# Oakland City Planning Commission

## STAFF REPORT

Case File Number PLN15-378; ER15-004

<b>Project Name and Location:</b>	<b>Oak Knoll Mixed Use Community Plan Project</b> , located on the former Oak Knoll Naval Medical Center Property at 8750 Mountain Boulevard, bounded by Keller Avenue and Mountain Boulevard. APNs: 043A-4675-003-21, 043A-4712-001 (portion), 043A-4675-003-19, 043A-4675-003-16, 043A4678-003-17 {roadway easement), 043A-4675-003- 30 (roadway easement) 048-6865-002-01, and 043A-4675-74-01.
<b>Proposal:</b>	Master Planned community on approximately 188 acres consisting of 935 residences, 72,000 square feet of neighborhood commercial, 14,000 square feet of civic use (relocated historic Club Knoll building as a community center), open space, creek restoration and trails.
<b>Applicant/Owner:</b>	Oak Knoll Venture Acquisitions LLC, c/o Suncal, Sam Veltri (949) 777-4000
<b>Planning Permits Required:</b>	Rezoning, Planned Unit Development permit (Preliminary and Final Development Plans), Tentative Tract Map, and other permits and/or approvals

## PROPOSED SITE PLAN

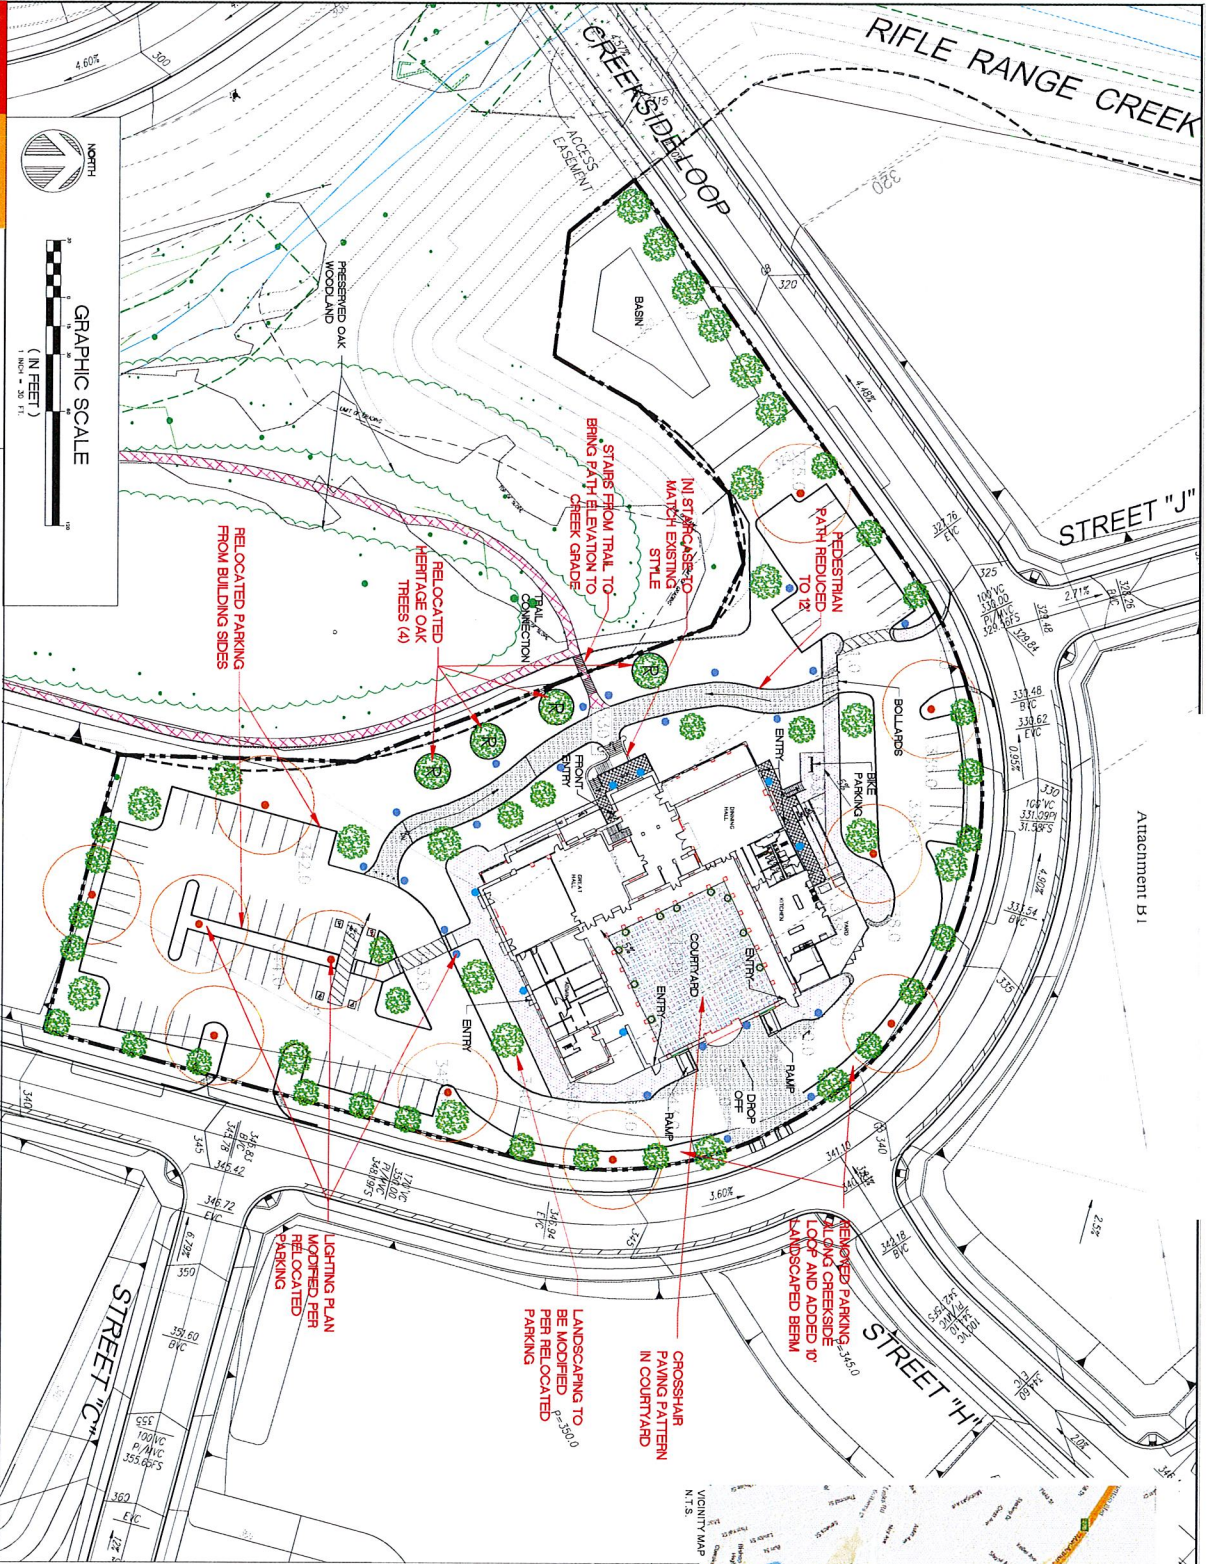
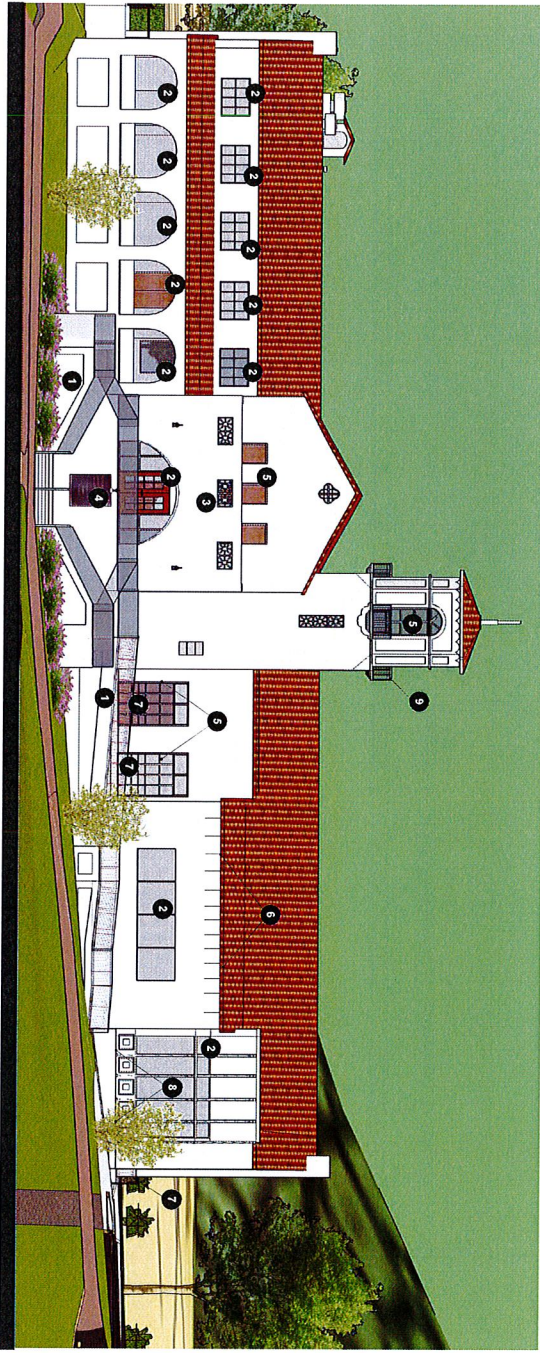
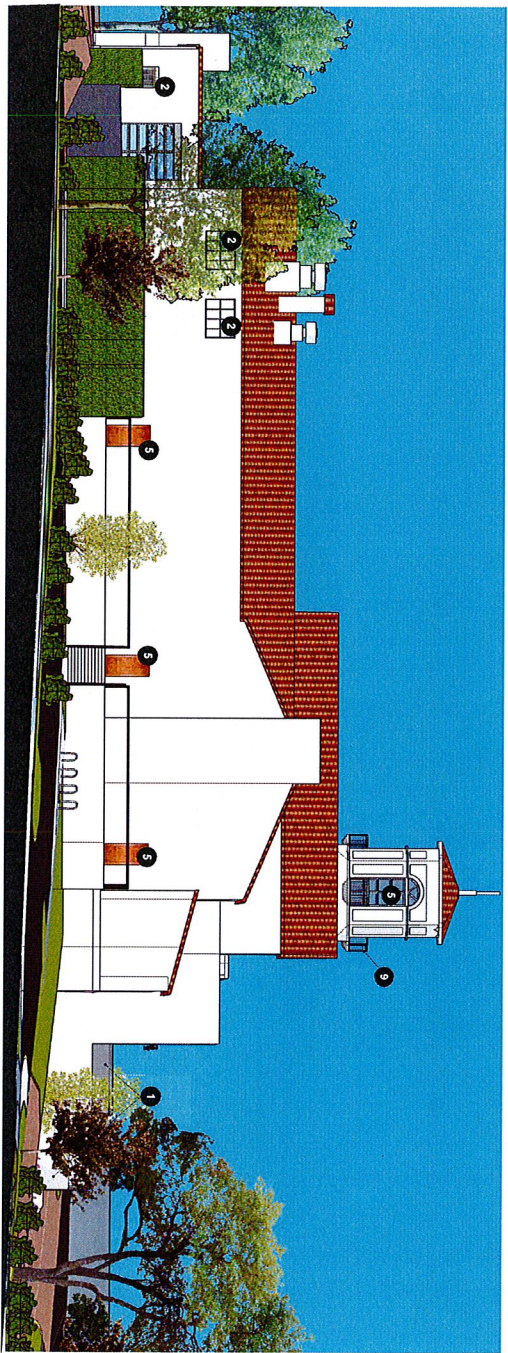
Suncal and Architectural Dimensions have updated their proposed site plan (see **Attachment B1**) to address certain of these DRC comments. The orientation of the Club Knoll building is retained as previously presented, with the design intent to relocate the building in a manner that is most compatible with the building’s original character and use. According to the Carey & Co. report

At its existing location, the front entrance to the Club Knoll courtyard is directly via a surface parking lot that occupies the “front yard” of the Club Knoll site. In response to DRC comments as to the appropriateness of parking directly in front of the newly relocated building, the updated site plan (see **Attached B1**) shows that previously proposed parking in the front of the Club Knoll building has now been removed and placed in larger surface parking areas to either side of the building. This updated design allows for a more attractive landscape in the immediate front of the building and the larger side-yard surface parking lots can accommodate more parking spaces than indicated in the previous design.

### West (Front) Elevation

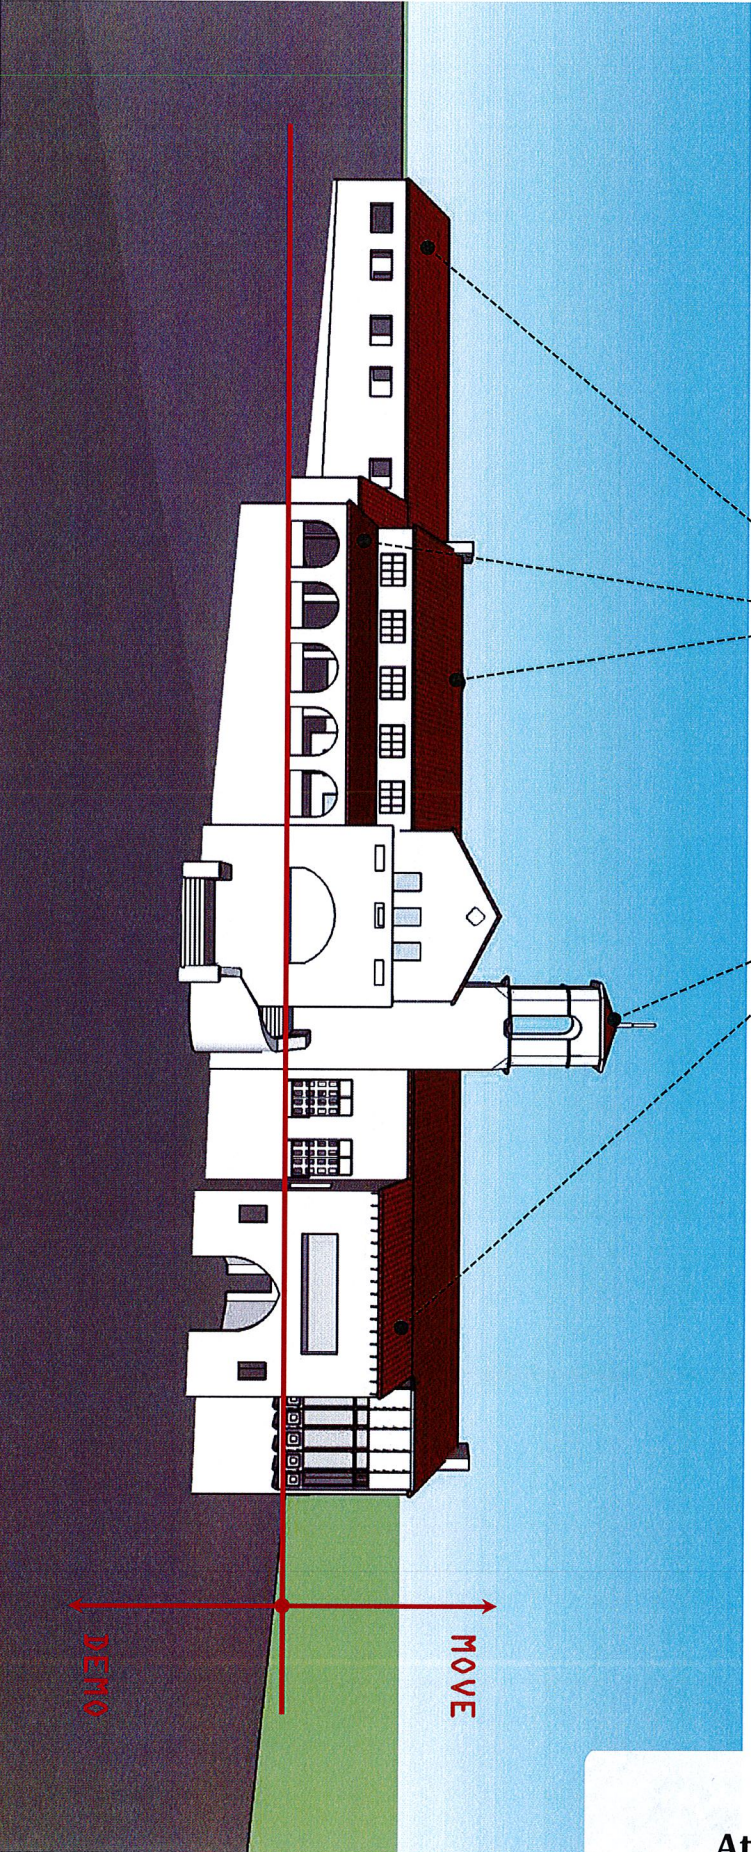
*(Relocation Evaluation, May 13, 2016)*, “people mainly accessed the building from the courtyard side after they parked their car, so the courtyard side of the structure is the primary entry side of the building.” Therefore, the primary entrance to the building from Creekside Parkway remains through the courtyard, with secondary pedestrian access via a pedestrian trail along the edge of the restored Rifle Range Creek corridor. The updated site plan illustrates a reduced width of the pedestrian pathway to 12 feet as an acceptable EVA route to this side of the building. Additionally, the building’s existing setting is built into the side of a knoll, such that three stories of the structure are exposed on the west elevation, and two stories are visible on the east. The proposed grading for the relocated Club Knoll site enables placement of the building on a sloping grade, such that even without the basement, the westerly elevation retains a taller, nearly 3-story appearance (see **Attached B2**).
